2 Description of Proposed Action and Alternatives, Revised

This chapter describes the specific elements of the new alternative (Alternative 3). It includes revisions to the project description; modifications to the location, timing, and type of activities; and changes in certain design elements. All revised figures are provided at the end of the chapter.

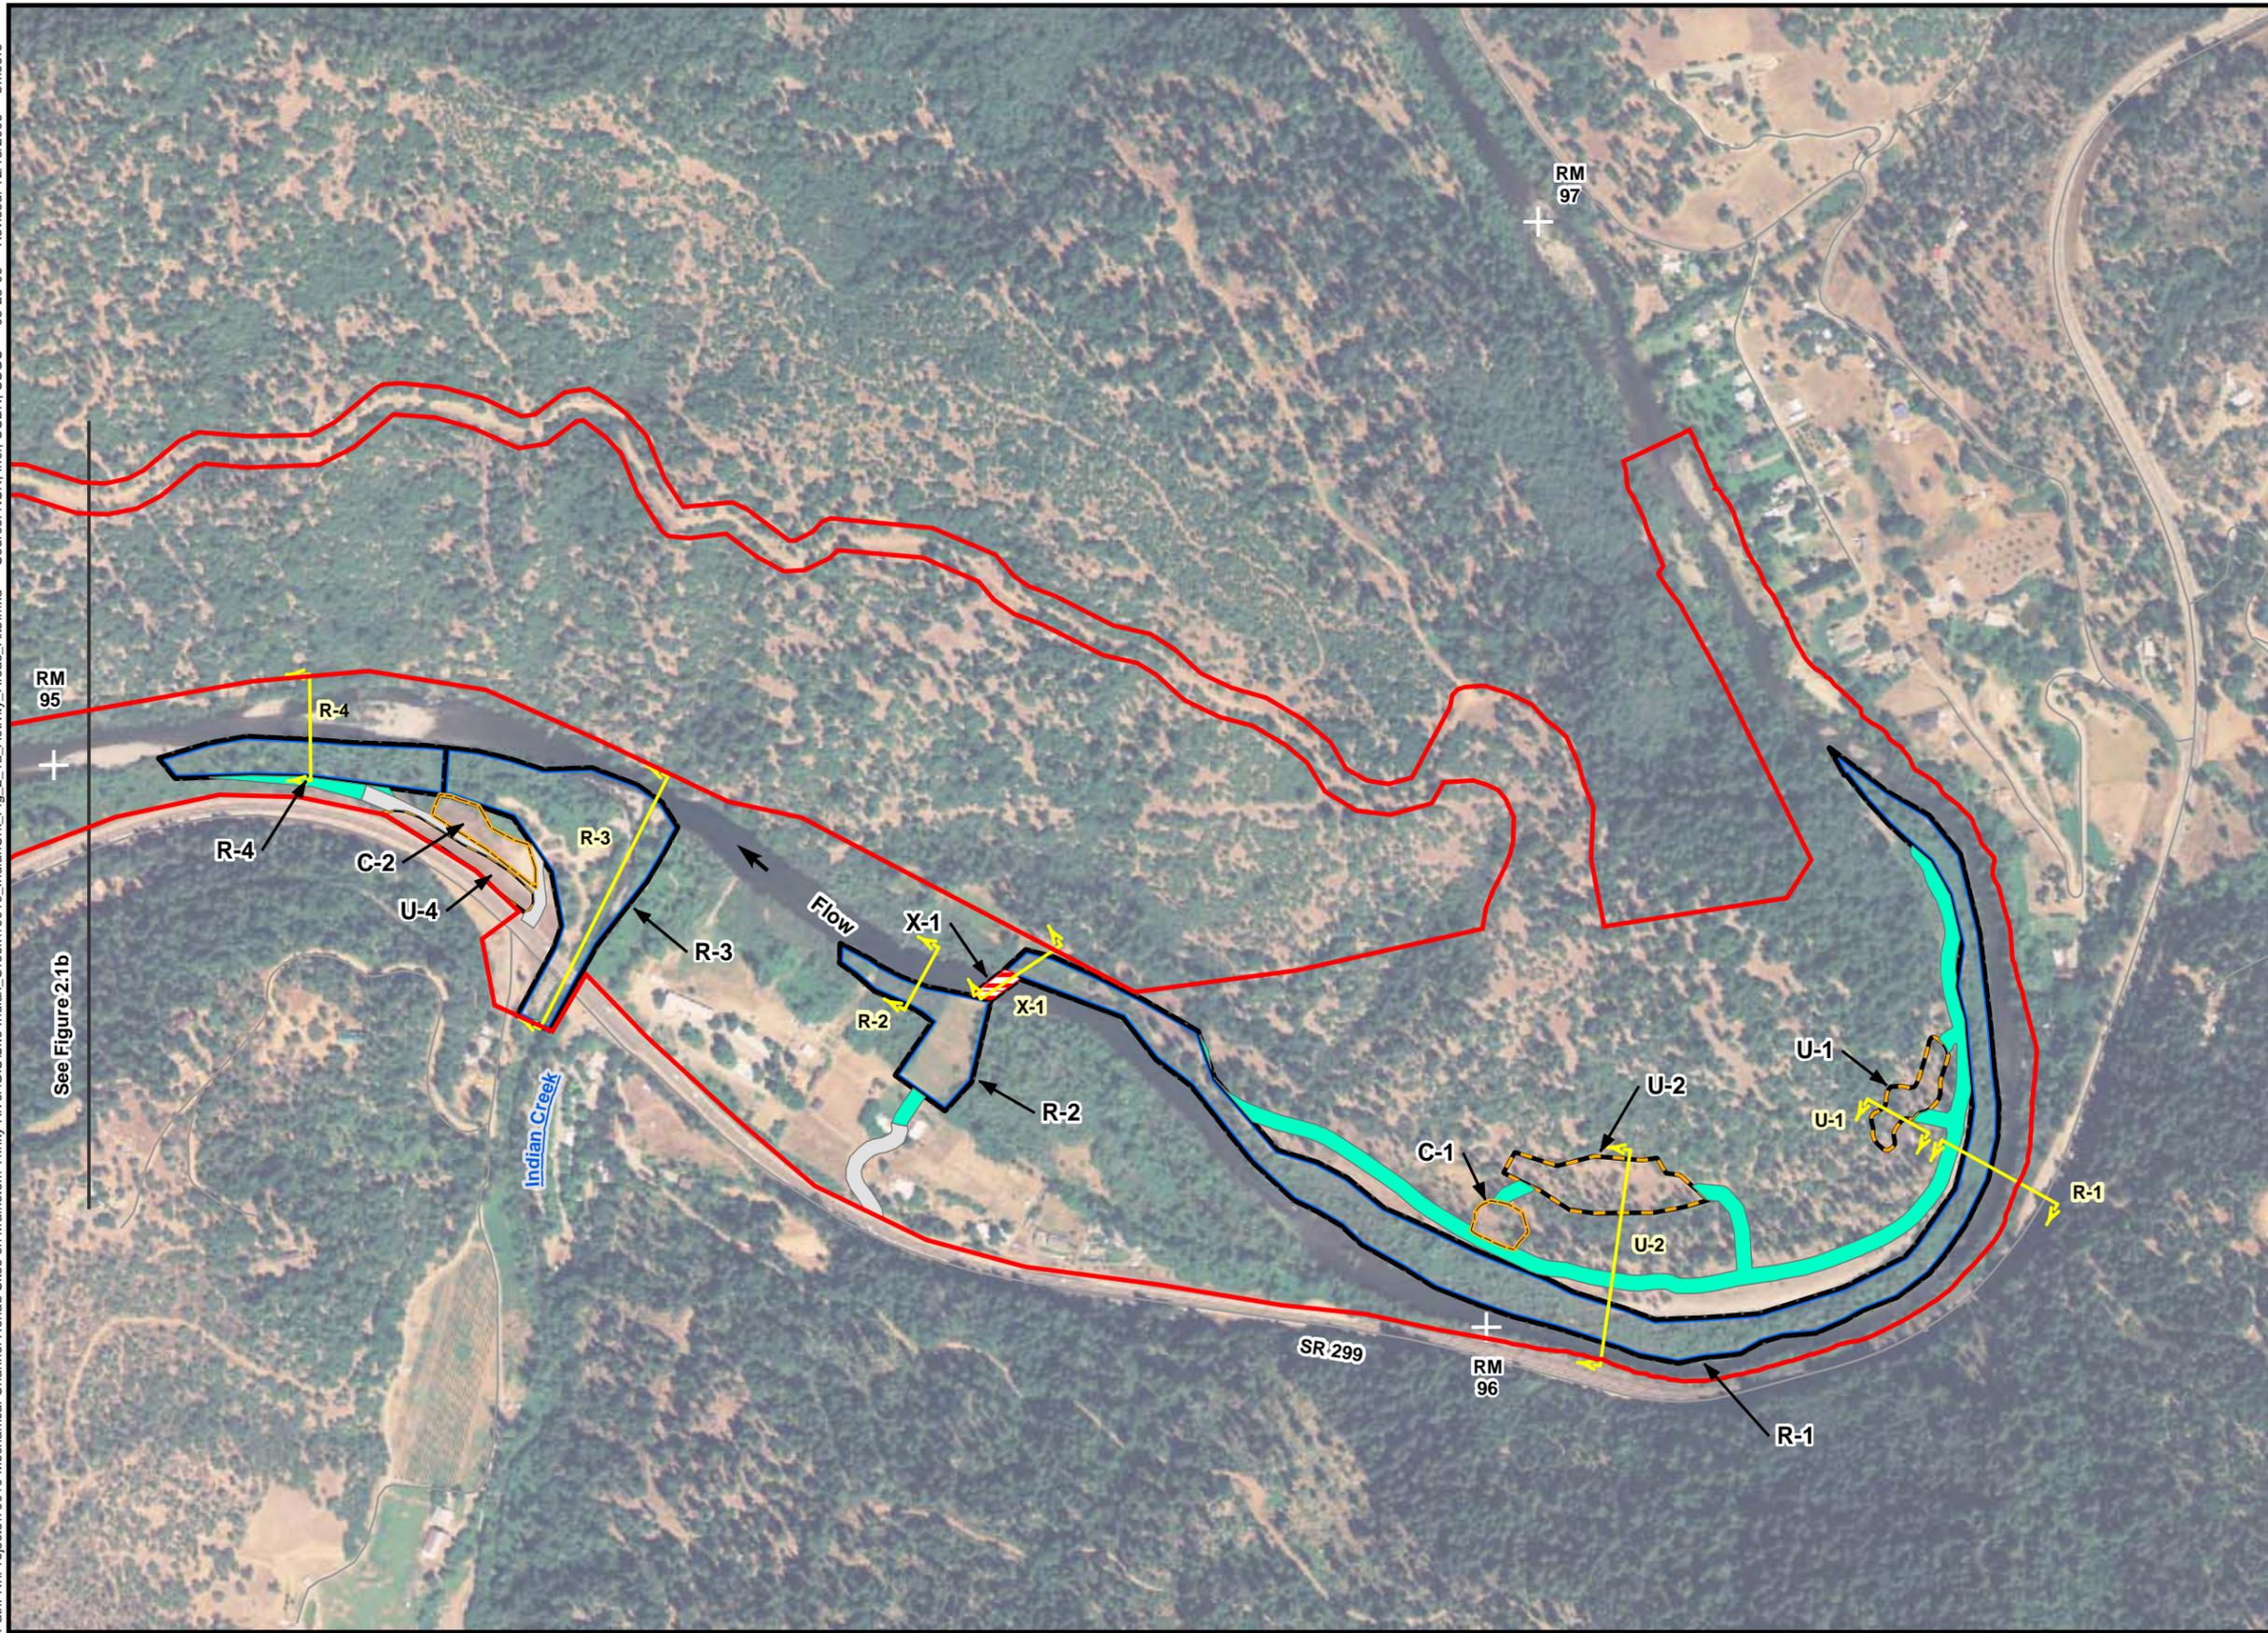
Alternative 3 adds three activity areas within the project boundary. An additional upland area (U-4) has been added in the general vicinity of Indian Creek (Revised Figure 2-1a). This area was added to reduce offsite transport of excavated materials. The remaining two areas are characterized as dredge tailing deposits (T-1 and T-2) on Revised Figure 2.1b. Areas T-1 and T-2 are incorporated into Alternative 3 as potential sources of alluvial material. This alternative also includes processing and transport of alluvial materials to off-site locations. After the EA/DEIR was issued, the TRRP identified an existing access

An additional Rehabilitation Area (U-4) has been added, as shown on Revised Figure 2.1a and in Revised Table 2-1. This area would be available to place excavated material on the left side of the Trinity River in the general vicinity of the SR 299 crossing of Indian Creek.

Path: R:\Projects\10010 Mechanical Channel Rehab Sites on Mainstem Trinity River\GIS\Site-Indian_Creek\10010_IndianCk_Fig.2.1b_Activity_Areas_Alt3.mxd Source: NSR, Inc.; USBR; USGS 05-25-06 Revised: 12/18/2006 bmoore

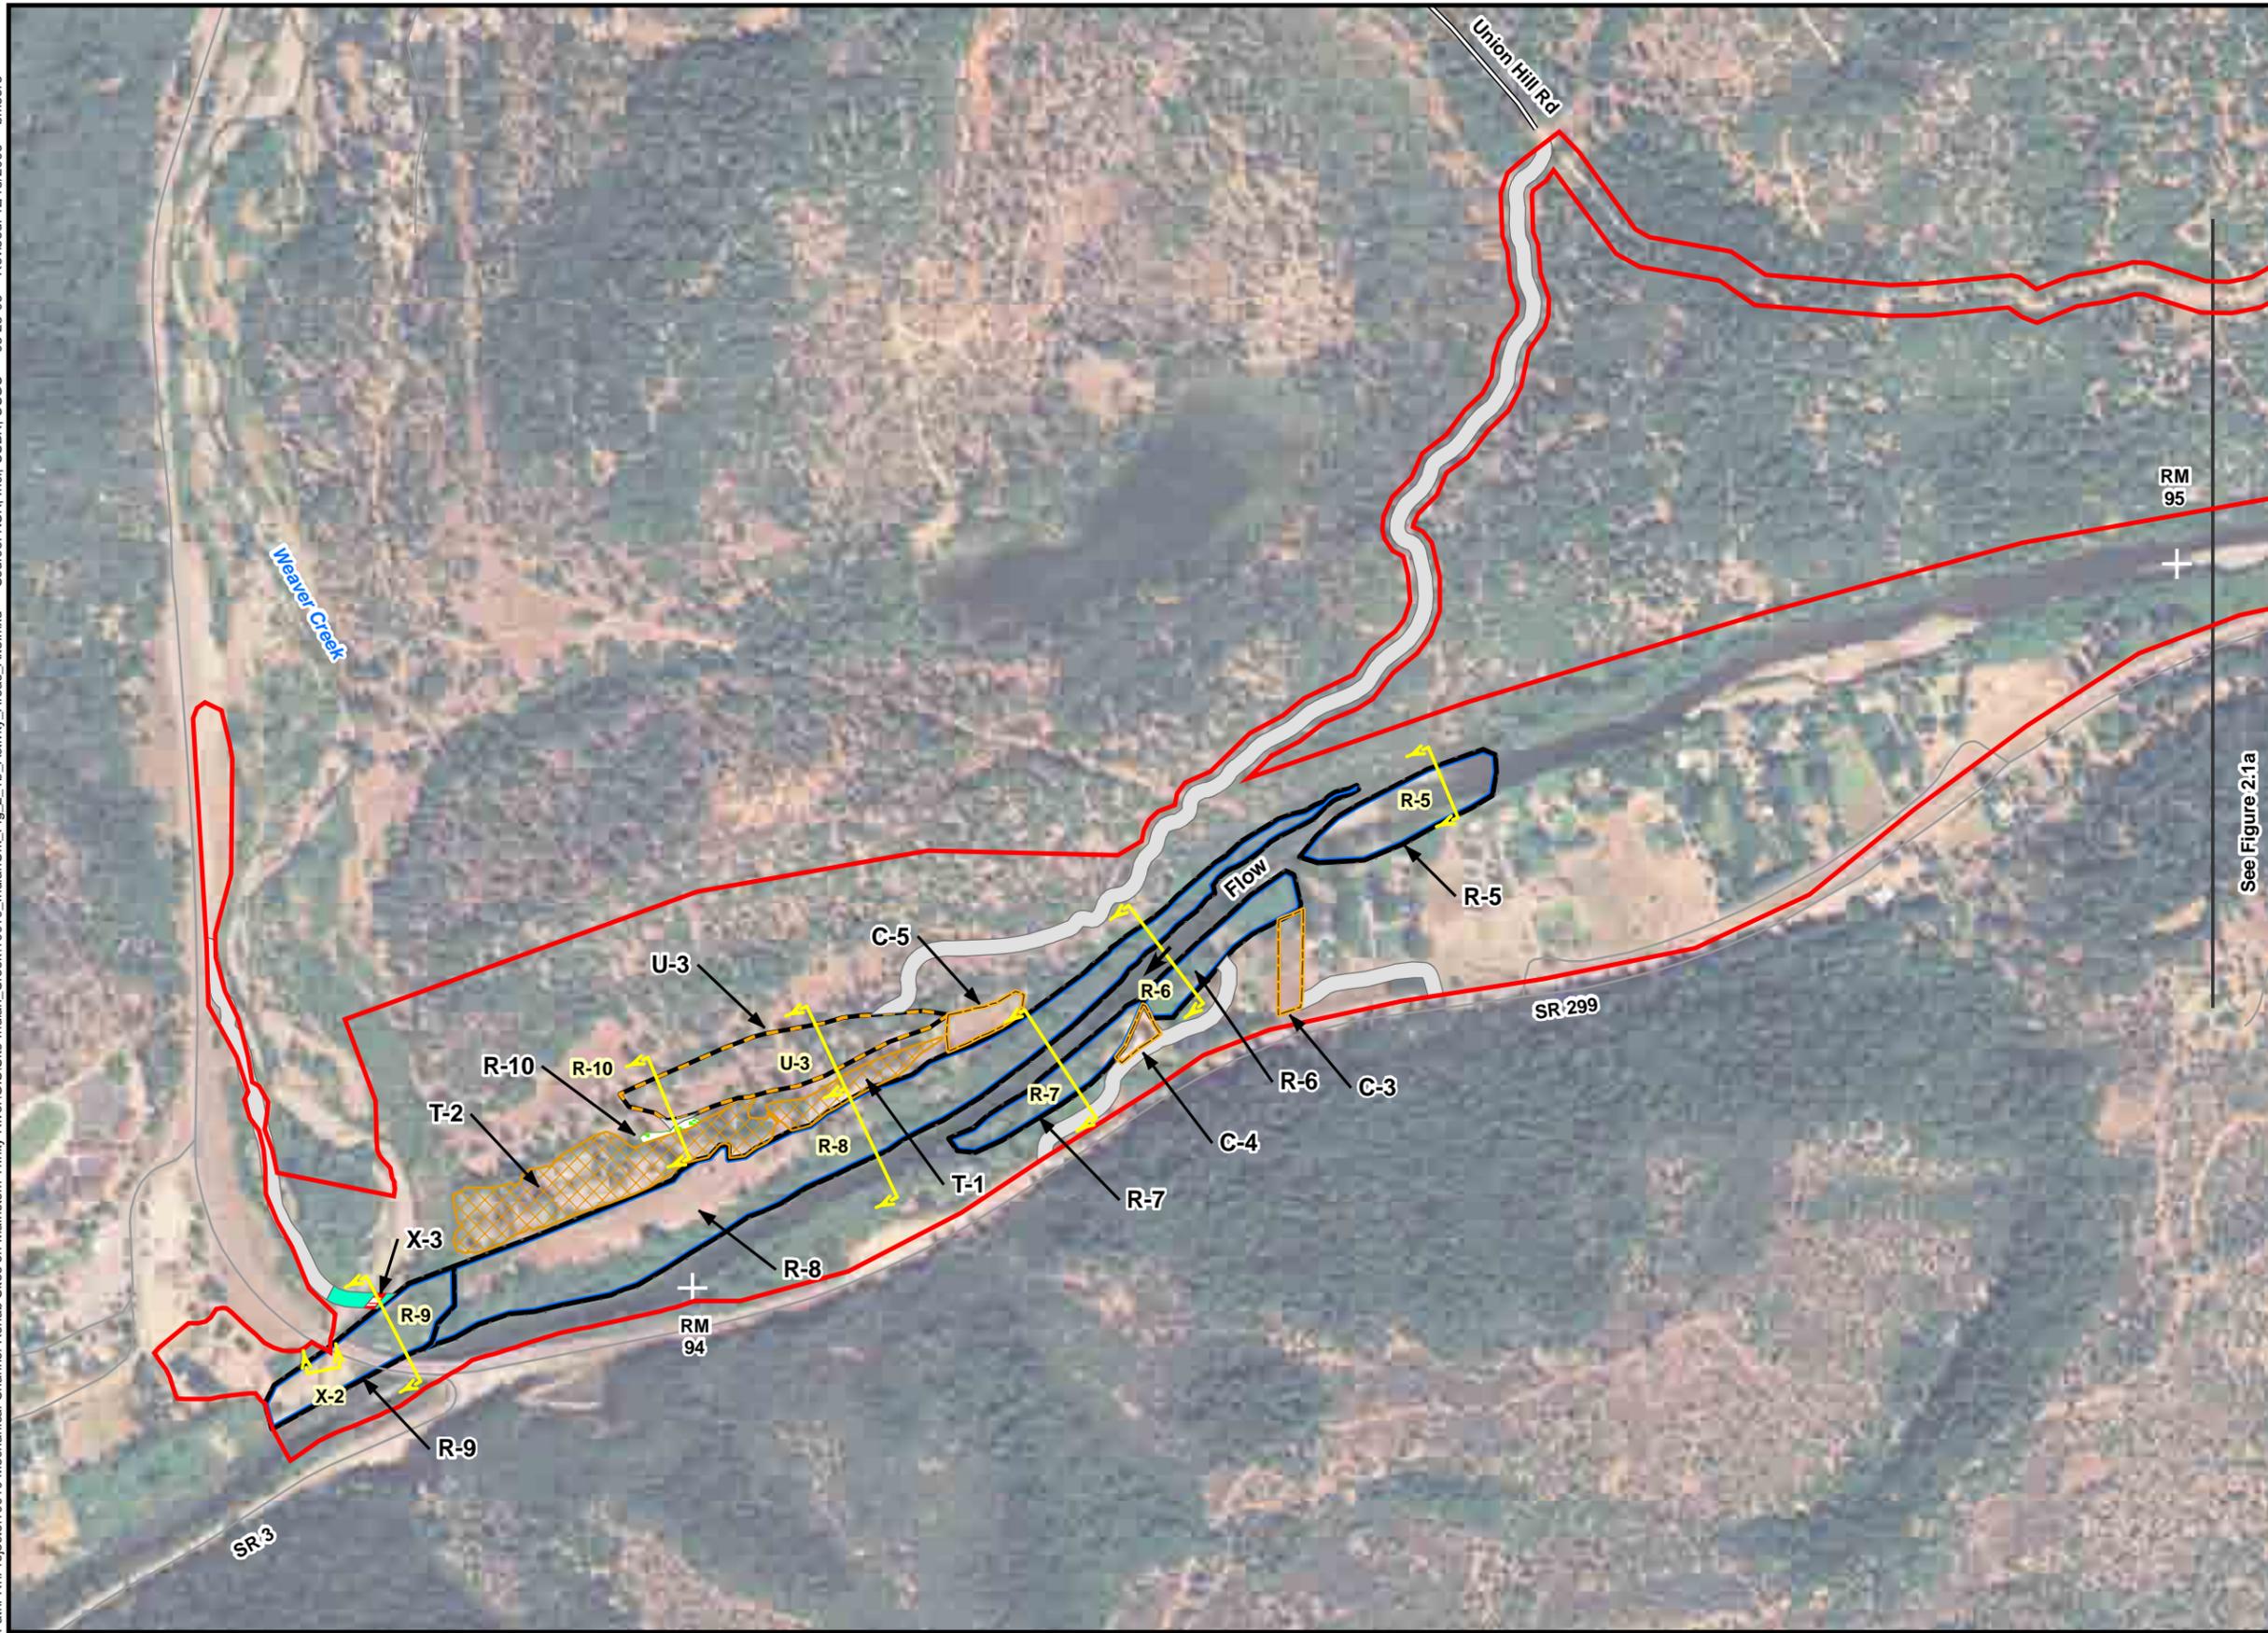
The development of Alternative 3 required expansion of the site boundary to accommodate an alternative access route to the activity areas on the downstream (west side) of the project site. Revised Figure 2.1b illustrates the changes in the site boundary under Alternative 3. This figure also shows the location of the boundary with respect to the Caltrans right-of-way (ROW) for State Route 299 (SR 299).

road adjacent to Weaver Creek that provides a direct connection to SR 299. This road segment is shown on Revised Figure 2.1b. This figure also identifies an alternative access route across Weaver Creek (X-3) that is incorporated into Alternative 3. Table 2-1 has been revised to include the new activity areas.

R-3 Cross Section

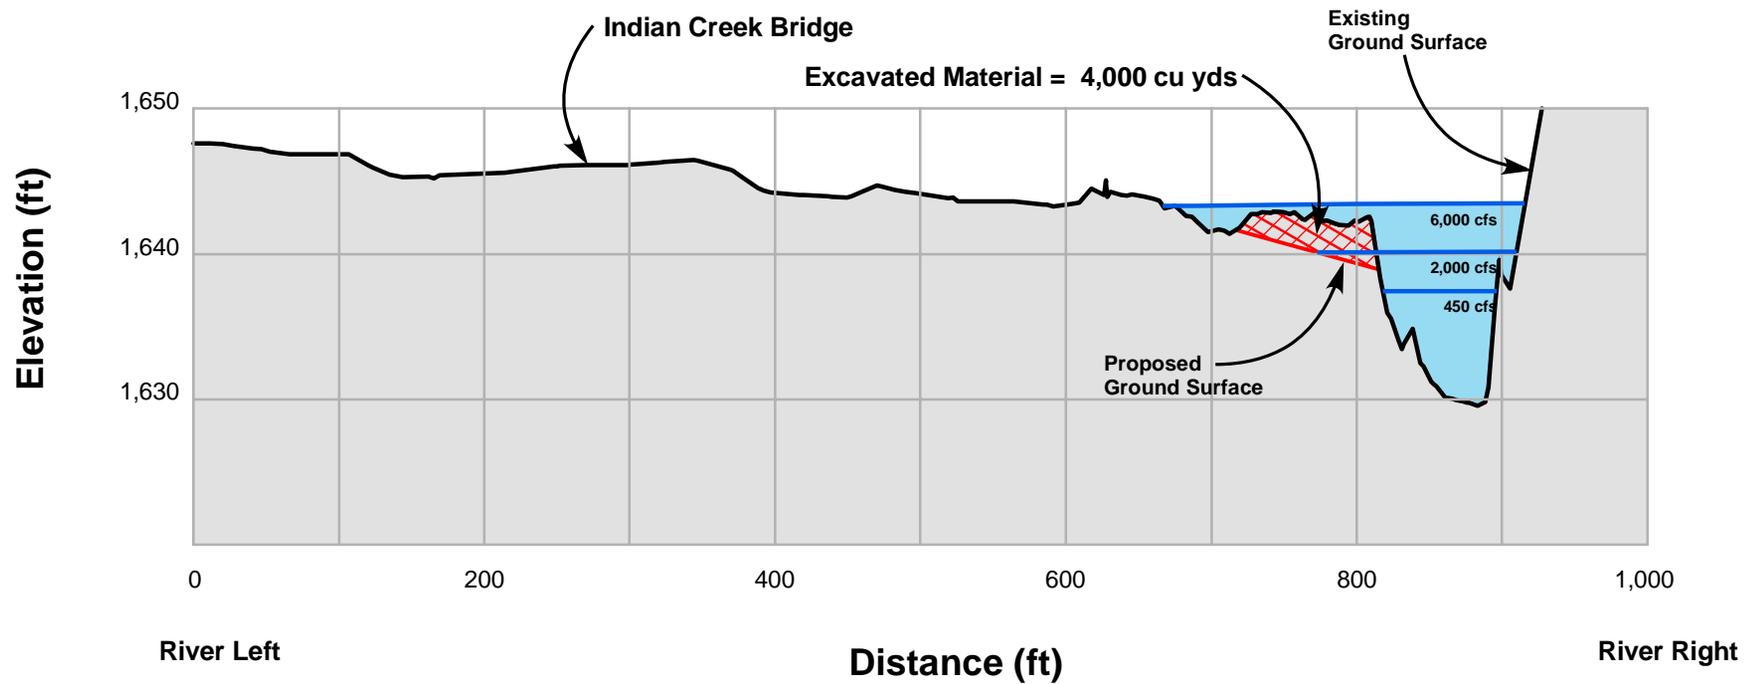
- R-1. No change.
- R-2. No change.
- R-3. The level of activity at this area has been reduced because geomorphic changes will continue to occur at the mouth of Indian Creek regardless of the activity. Consequently, activity at R-3 is limited to berm removal on the left bank of the Trinity River downstream of Indian Creek. Berm removal would provide an opportunity for the Indian Creek delta to shift in response to changes in the flow and sediment regimes. Such shifts would result in changes to the location and type of alluvial deposits at the mouth of Indian Creek. Berm removal downstream of Indian Creek's delta would allow tributary flows to augment routing of bed load along the mainstem Trinity without requiring mechanical activities to modify the deltaic deposit at the mouth of Indian Creek. Revised Figure 2.5c illustrates berm removal at this area.

R-8 Cross Section

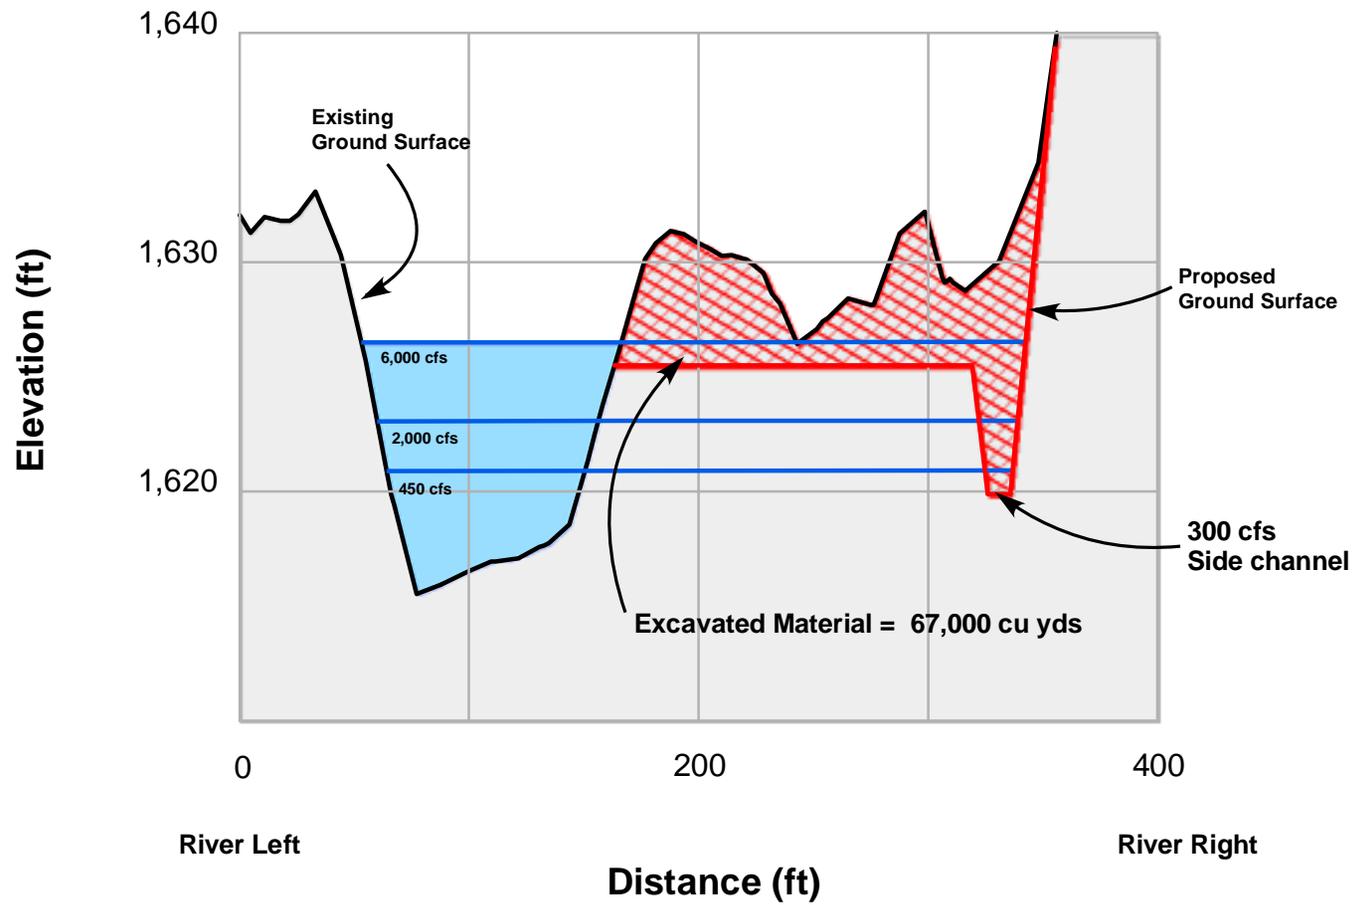
- R-6. No change.
- R-7. No change.
- R-8. Activity in this area has been modified to include construction of a side channel that would be functional at 300 cfs (low-flow conditions). The 1,000 cfs side channel would not be constructed. A floodplain surface would be constructed to function at 6,000 cfs. A 4,500 cfs floodplain surface would not be constructed. As materials are transported off-site each year, contouring and floodplain functionality would be maintained. Revised Figure 2.5h illustrates activities upstream of the Weaver Creek delta. In addition to floodplain surfaces, this figure

illustrates the location and configuration of a 300 cfs side channel on the right side of the Trinity River.
